HISTORIC AND DESIGN REVIEW COMMISSION

December 19, 2018

HDRC CASE NO: 2018-616
ADDRESS: 1405 S FLORES ST
LEGAL DESCRIPTION: NCB 1009 BLK LOT 40B
ZONING: I-1,HS
CITY COUNCIL DIST.: 1
LANDMARK: SAP Cleaners & Dyers
APPLICANT: Kris Feldmann
OWNER: HB Properties I, LLC
TYPE OF WORK: Rehabilitation, exterior modifications, signage, storefront restoration, window replacement, roofing
APPLICATION RECEIVED: December 05, 2018
60-DAY REVIEW:
REQUEST:

Antiques Warehouse Lofts
November 30, 2018

PROPOSED FRONT ELEVATION - EAST

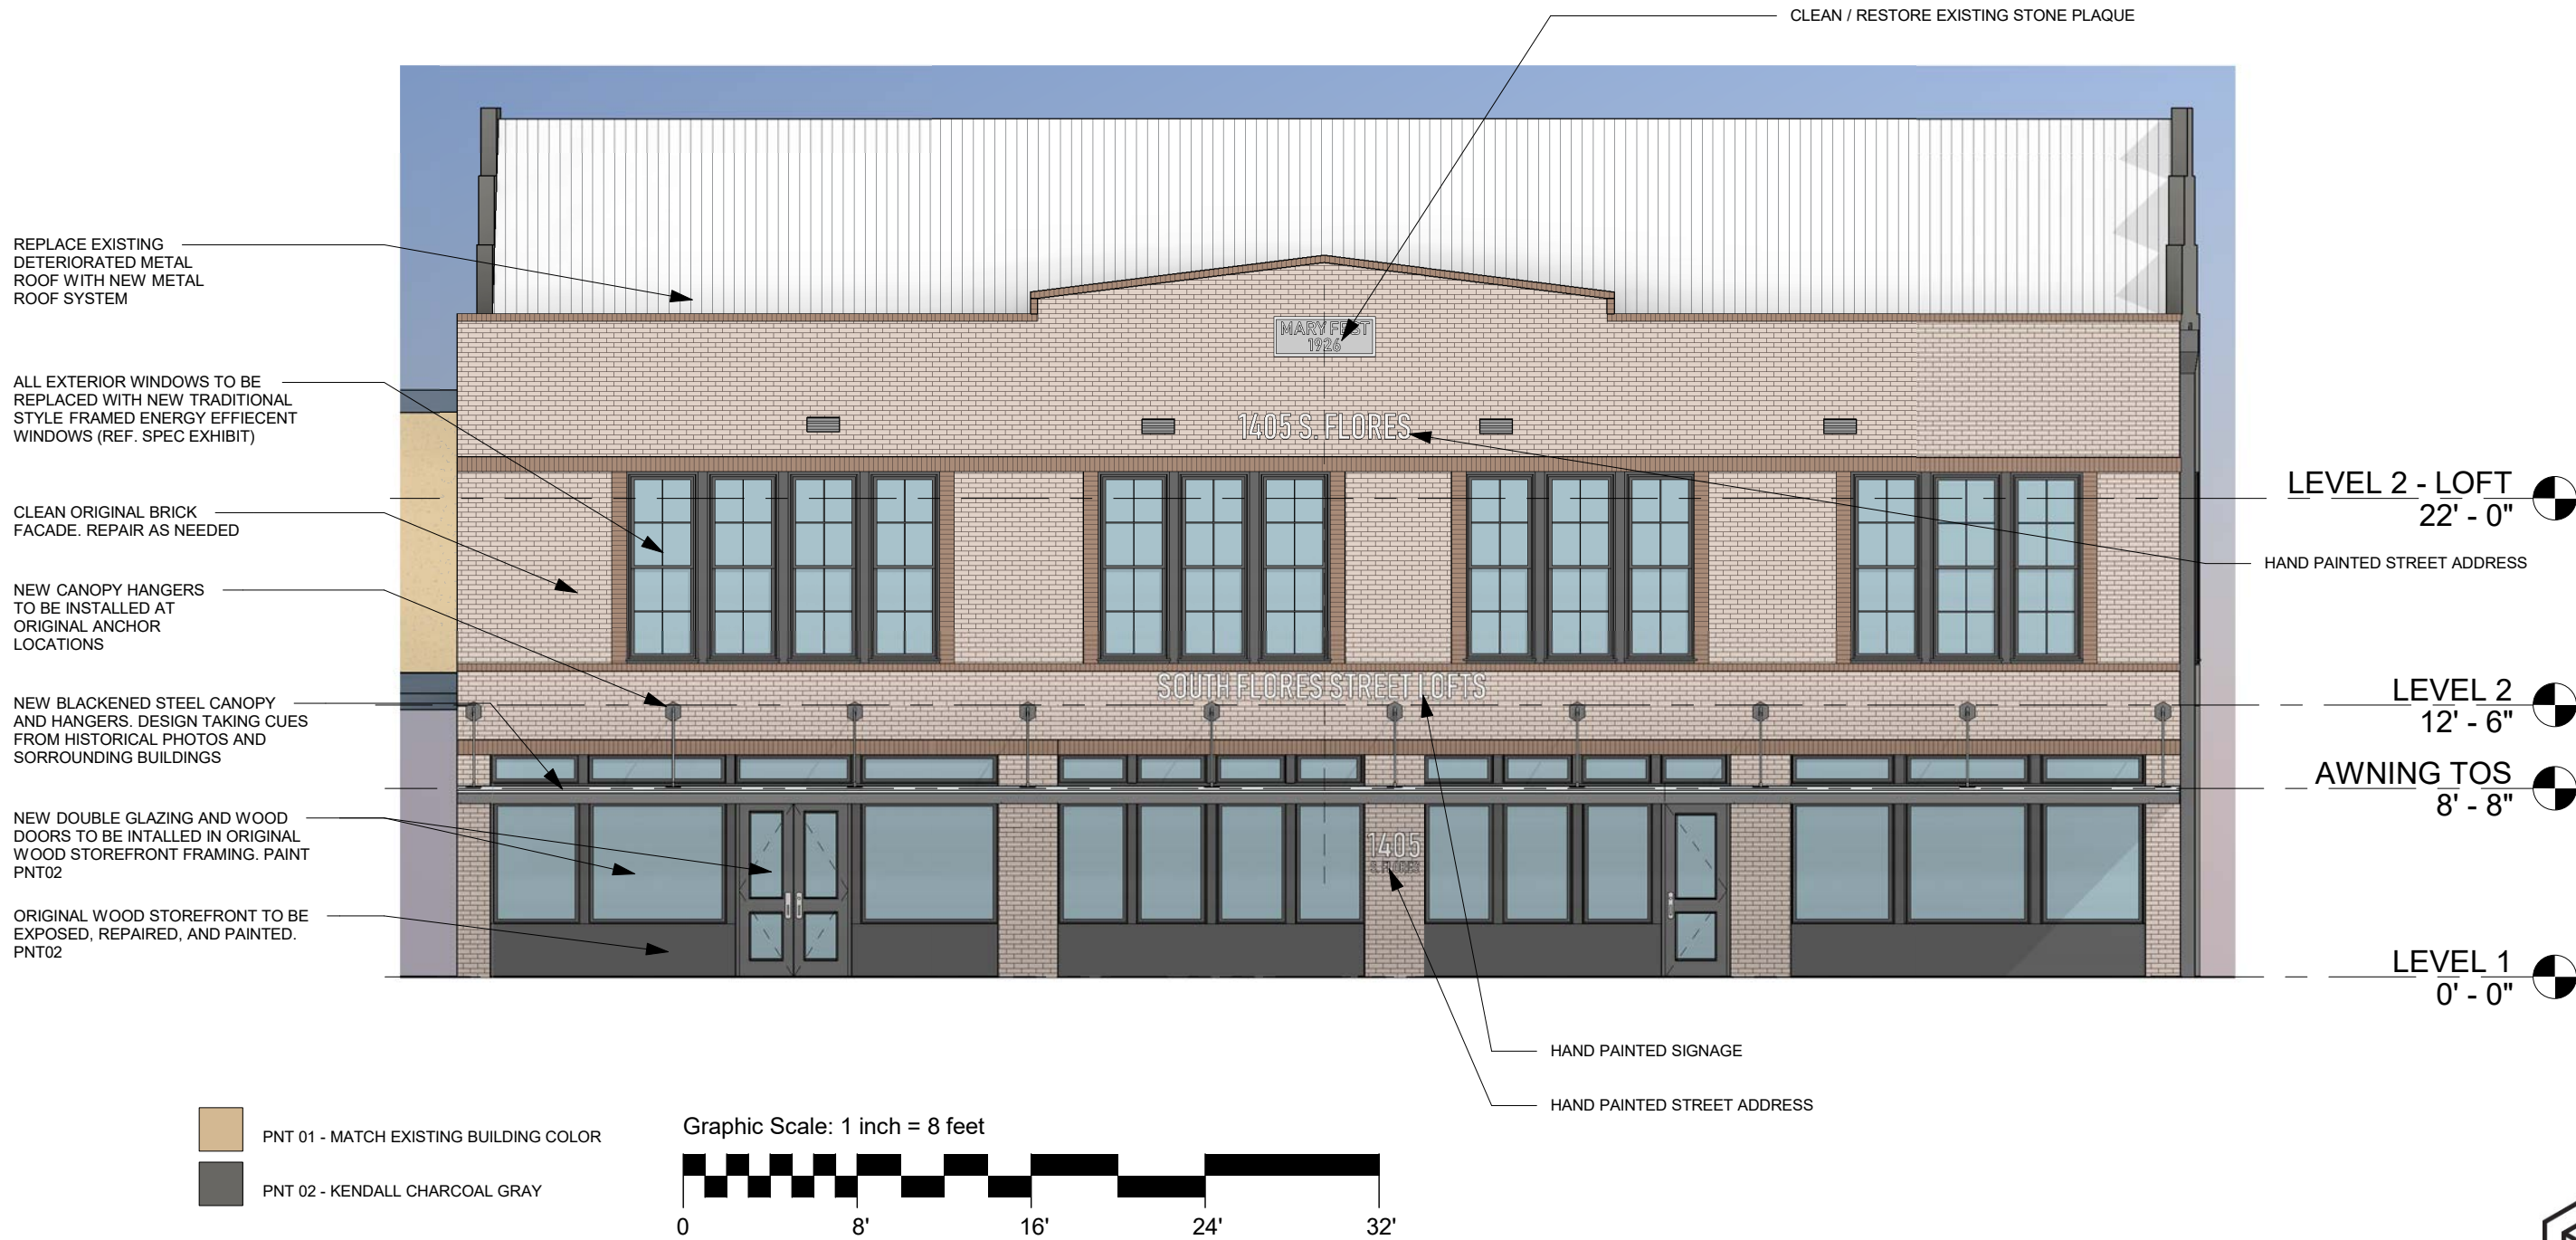
- c. **STOREFRONT SYSTEM** – As noted in finding a, the original storefront system has been removed. The applicant has proposed to remove the existing brick infill and expose the original profile. The proposed storefront restoration will consist of a storefront system that features transom windows above the canopy height, a wood framed storefront system with knee walls featuring a height comparable to those found on the adjacent historic structures. The existing bays, which are visible due to the exposed brick columns, will remain at their current width. Generally, staff finds the proposed restoration of the storefront system to be appropriate and consistent with the Guidelines. Staff finds that detailed elevation drawings of the proposed storefront system should be submitted to staff for review and approval prior to the issuance of a COA. These documents should include mullion dimensions and a window and door schedule.

- d. **AWNING INSTALLATION** – The Guidelines for Exterior Maintenance and Alterations 11.B.ii. notes that canopies and awnings should be added based on accurate evidence of the original, such as photographs. If photographs do not exist, new canopies should be designed to be consistent with the architectural style of the building. The applicant has noted the re-use of existing anchor points for canopy rods. Staff finds the proposed canopy installation to be appropriate; however, the applicant is to submit a canopy detail to staff for review and approval prior to the issuance of a COA.

- g. **SIGNAGE (Painted)** – The applicant has proposed to paint signage on the historic brick façade to read “South Flores Street Lofts”, and “1405 S. Flores”. The structure currently features non-original, painted signage. Staff finds the proposed locations and sizes to be appropriate; however, the signs should be painted with a product that can be removed without causing damage to the historic brick façade.

- i. That the applicant submit detailed construction documents for the proposed storefront system's restoration as well as the proposed canopy as noted in findings c and d. These documents should include dimensions and a door and window schedule.

- i. That the applicant submit detailed construction documents for the proposed storefront system's restoration as well as the proposed canopy as noted in findings c and d. These documents should include dimensions and a door and window schedule.
- ii. That exact sizes of the proposed signage be submitted to staff for review. Signage totals should not exceed fifty (50) square feet. Any paint for signage should be submitted to staff for review. The paint product should have the ability to be removed without causing damage to the historic brick and should be water permeable.

PROPOSED REAR ELEVATION - WEST

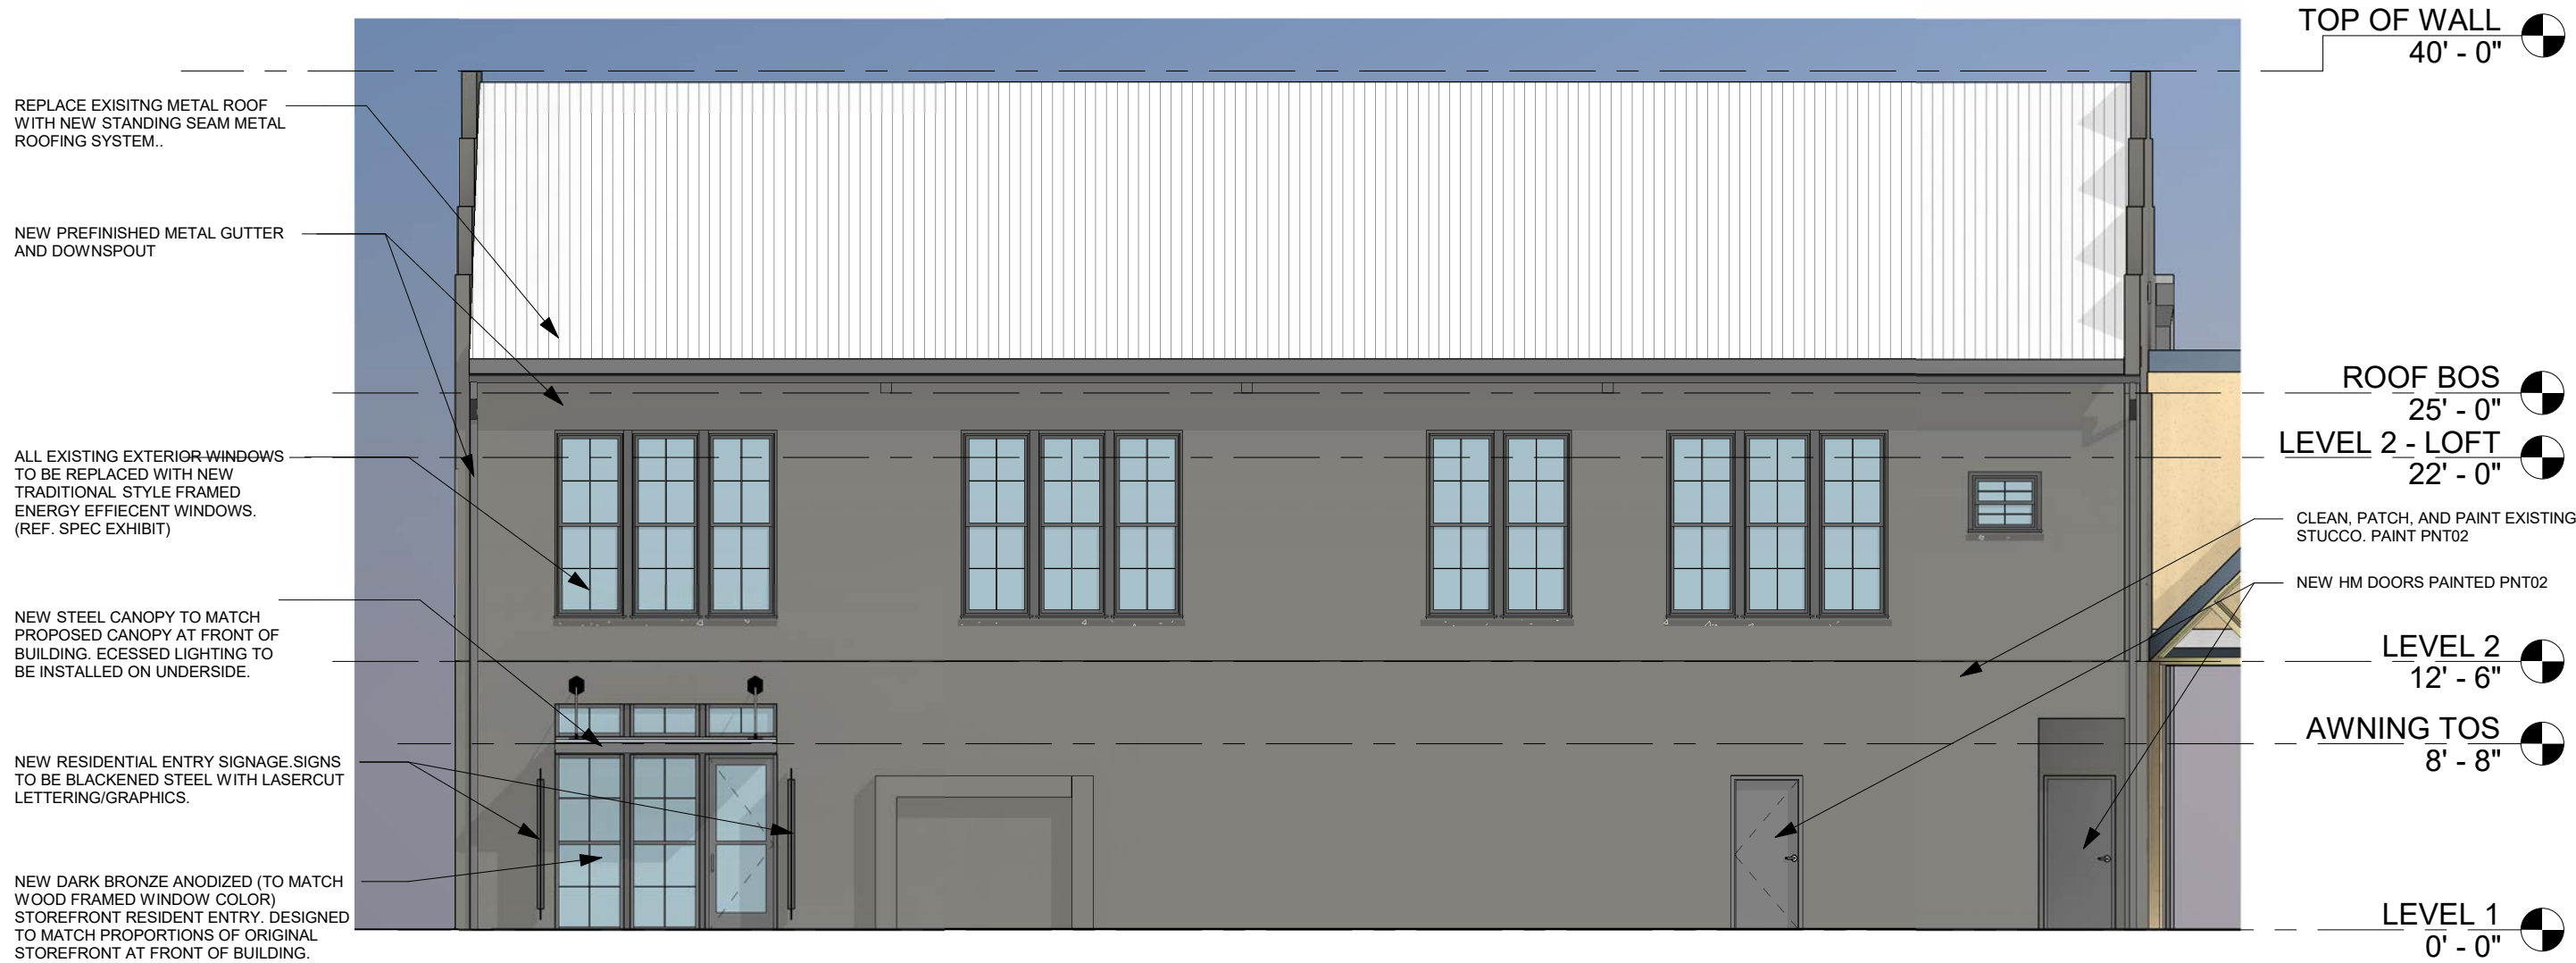
- f. **REAR ENTRY** – The applicant has proposed to modify an existing, rear entry door to feature a contemporary storefront system. The system will feature anodized aluminum with an entrance canopy and transom windows. Given its location on the rear façade, staff finds this entrance modification to be appropriate. Staff finds that detailed elevation drawings of the proposed storefront system should be submitted to staff for review and approval prior to the issuance of a COA. These documents should include mullion dimensions and a window and door schedule.

- h. **SIGNAGE (Blade)** – At the rear of the historic structure at the location of the proposed modified rear entrance, the applicant has proposed to install two blade signs that double as weather screens for the proposed entrance. These elements will read “Flores Lofts, 1405”. Staff finds the general size and location of these to be appropriate.
